**THE SCHOOL DISTRICT OF PHILADELPHIA
Office of Capital Programs
440 North Broad Street, 3rd Floor – Suite 371
Philadelphia, PA 19130**

Addendum No. 001

**Subject: 2020 Classroom Modernizations
SDP Contract Numbers: B-019 C of 19/20 & B-021 C of 19/20**

**Location: Ellwood School
6701 N. 13th St, Philadelphia PA 19126**

DRAWING A6.1 – ROOM FINISH SCHEDULE & DOOR SCHEDULE

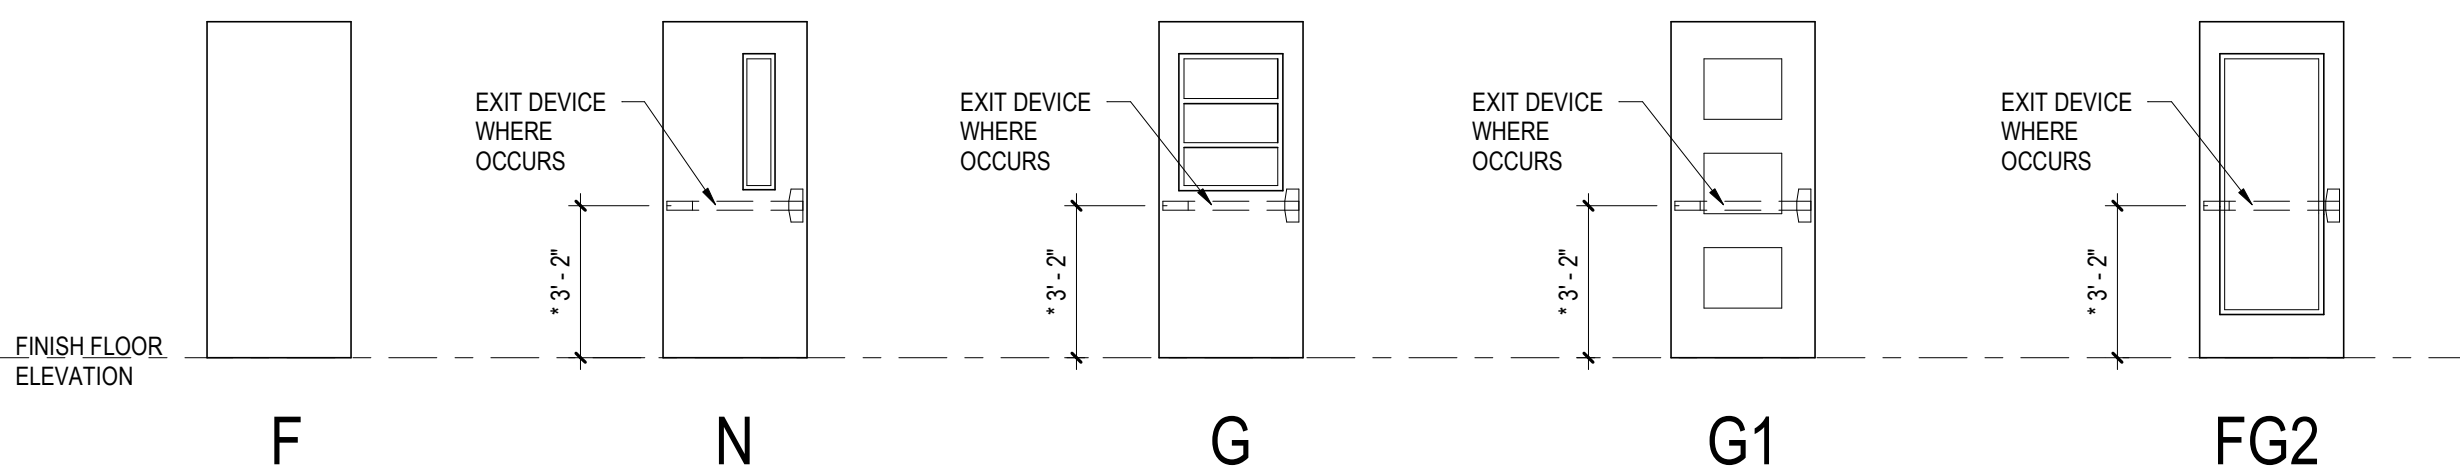
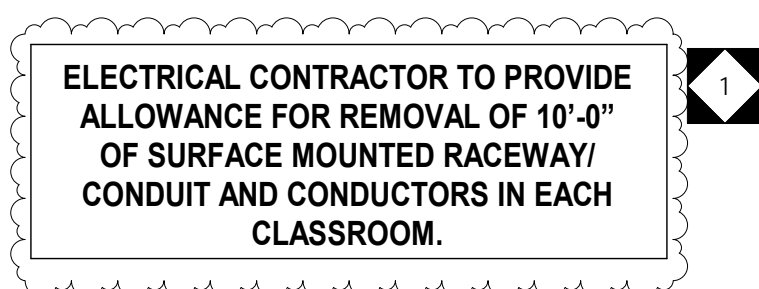
1. REVISE Room Finish schedule as indicated:
 - a. REVISE column “COLOR SCHEME” at ROOMS 108, 211, 212 to correspond to Color Scheme “C”.
 - b. REVISE column “COLOR SCHEME” at ROOMS 208, 210 to correspond to Color Scheme “D”.

2. REVISE Color Scheme Schedule as indicated:
 - a. REVISE Color Scheme A to read as: “COLOR SCHEME A – KINDERGARTEN”.
 - b. REVISE item no. 6 to read as: “6. VINYL COMPOSITION TILE, ACCENT '2': ARMSTRONG, NO. 51947 BASIL GREEN”

- c. ADD item no. 8 to read as: “8. VINYL BASE: JOHNSONITE, NO. 469 MYSTIFY”.
 - d. REVISE Color Scheme B to read as: “COLOR SCHEME B – FIRST GRADE AND SPECIAL EDUCATION”.

- e. REVISED item no. 3 to read as: “3. ACCENT PAINT 'B' TEACHING WALL: SHERWIN WILLIAMS, NO. SW6765 SPA”
 - f. REVISE item no. 5 to read as: “5. VINYL COMPOSITION TILE, ACCENT '1': ARMSTRONG, NO. 51927 FIELD GRAY”

- g. REVISE item no. 6 to read as: “6. VINYL COMPOSITION TILE, ACCENT '2': ARMSTRONG, NO. 57509 LEMON LICK”
 - h. ADD item no. 8 to read as: “8. VINYL BASE: JOHNSONITE, NO. 469 MYSTIFY”.

- i. REVISE Color Scheme C to read as: “COLOR SCHEME C – SECOND GRADE”.
 - j. ADD Color Scheme Information for Color Scheme C.
 - k. REVISE Color Scheme D to read as: “COLOR SCHEME D – THIRD GRADE”.

- l. ADD Color Scheme Information for Color Scheme D.
 - m. REVISE General Notes Item No. 7 to read as: “NOT USED”.

3 TYPICAL CLASSROOM LIGHTING CONTROLLER
E7.1 NTS

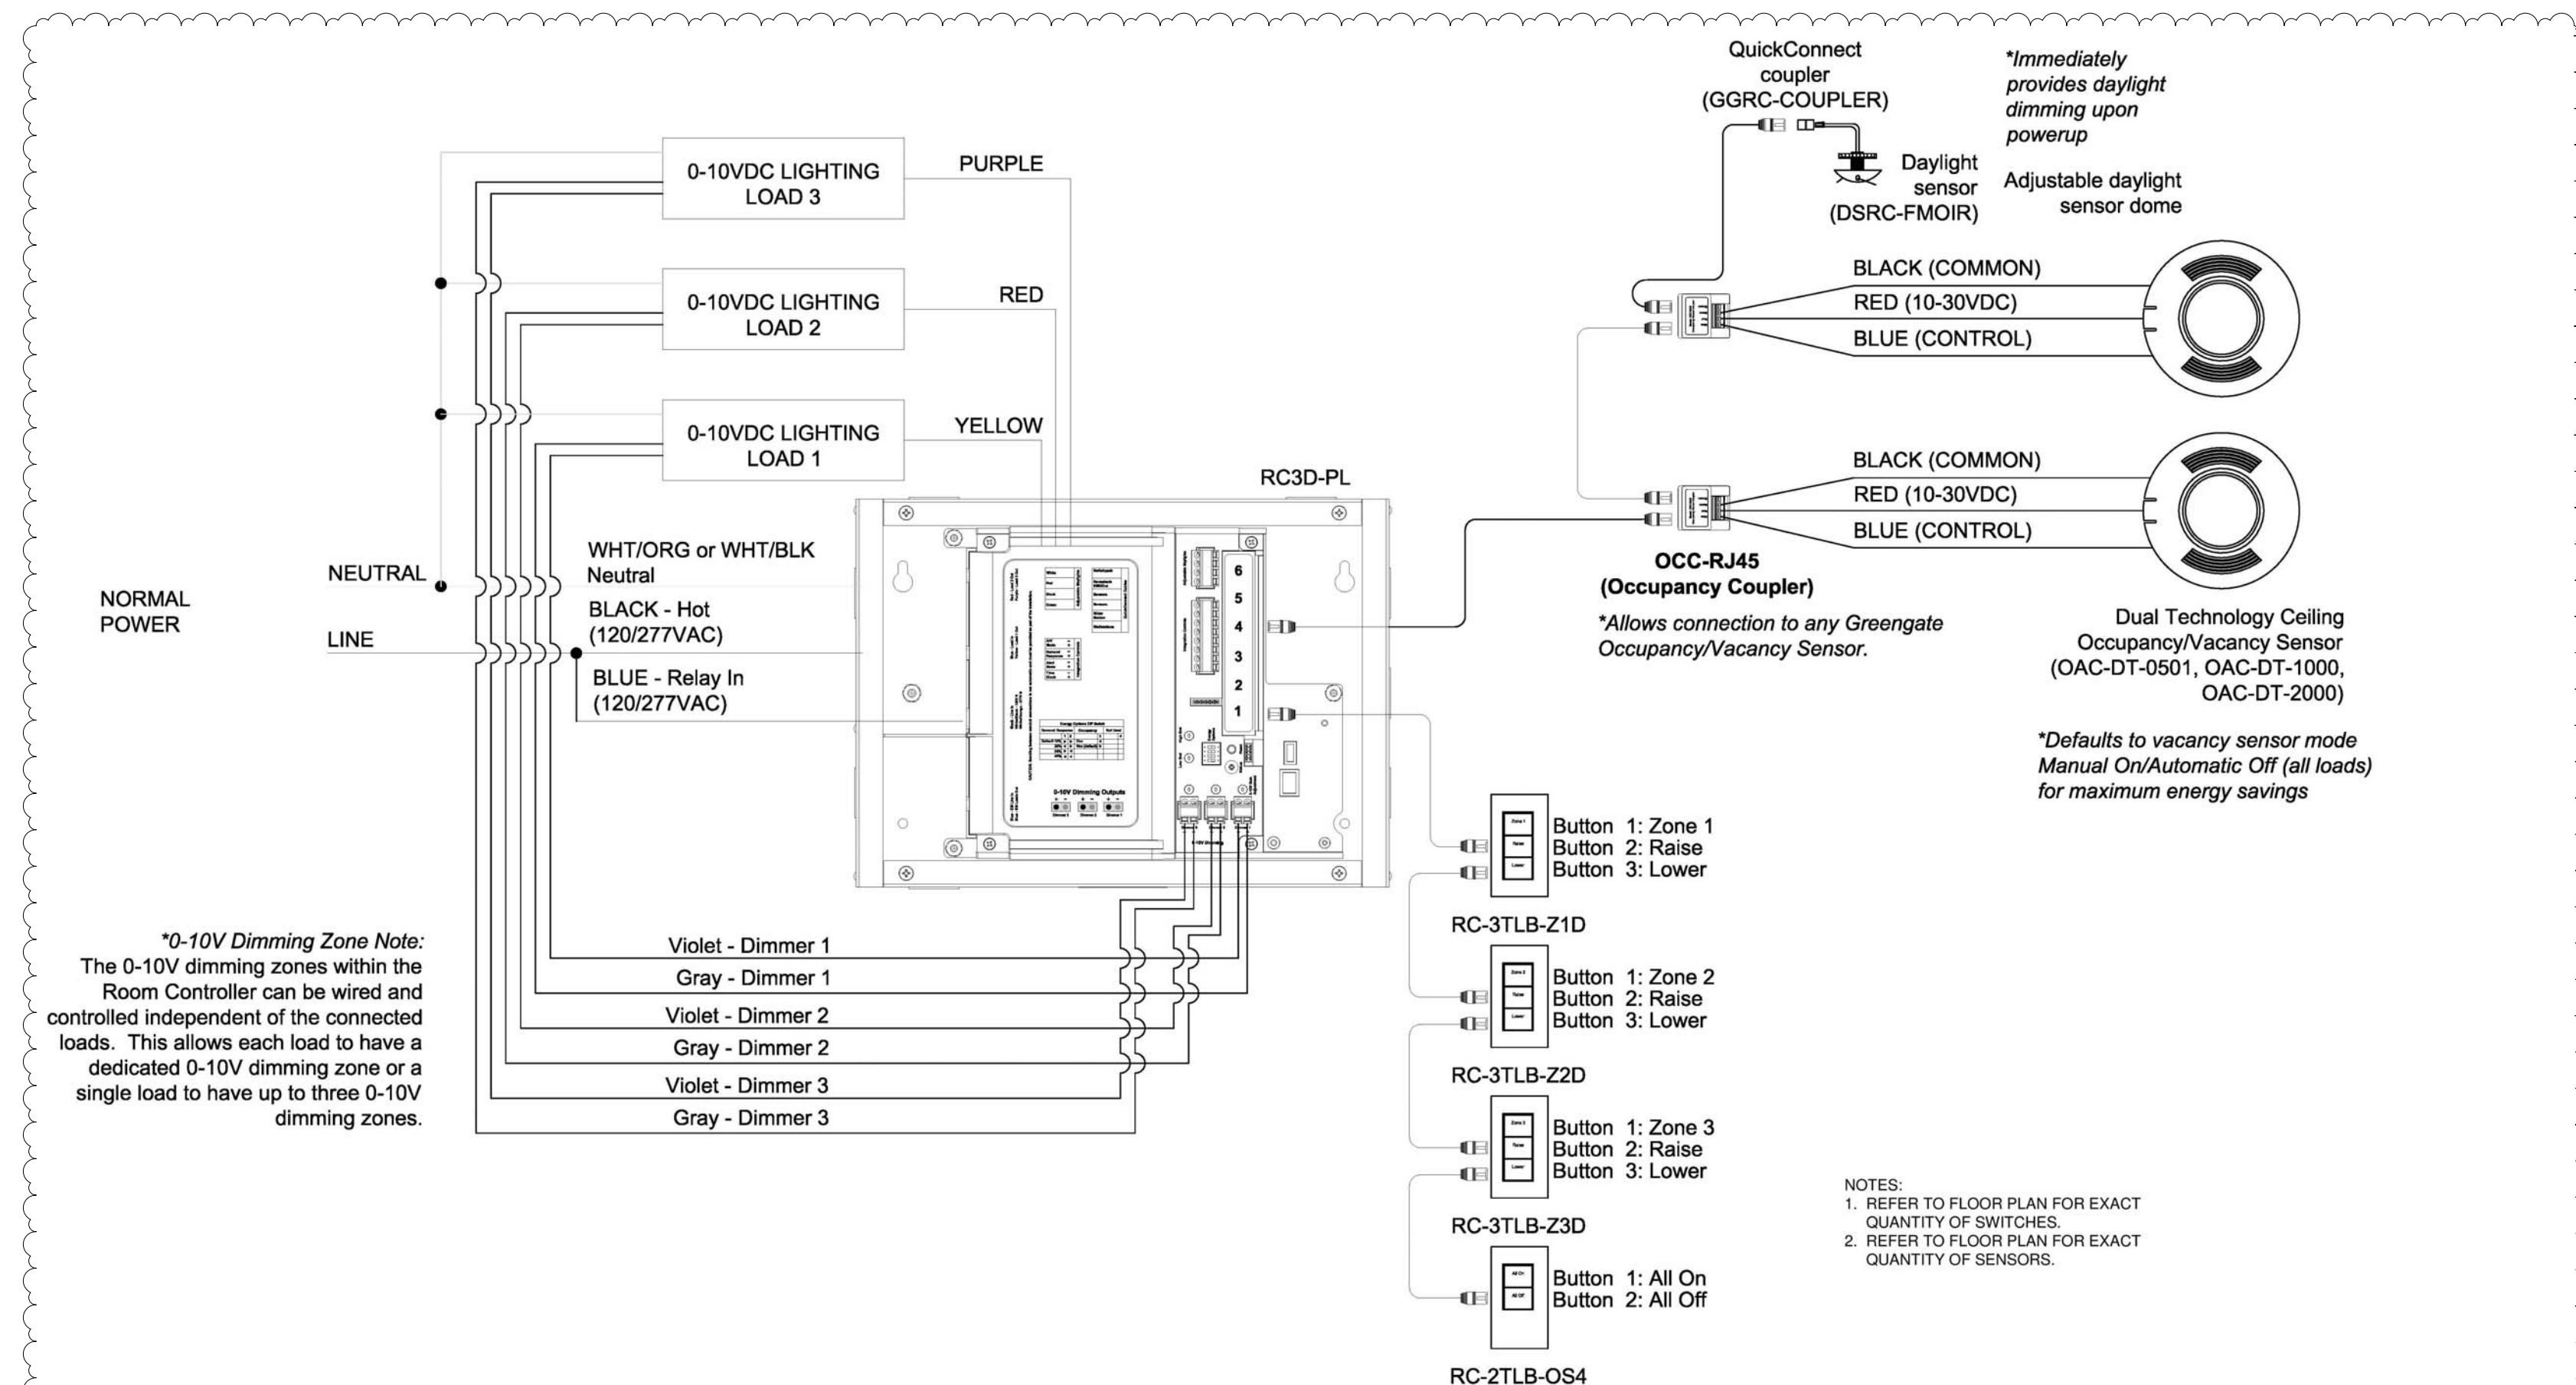
1. REVISE 3/E7.1 Typical Classroom Lighting Controller diagram as indicated on the drawings.
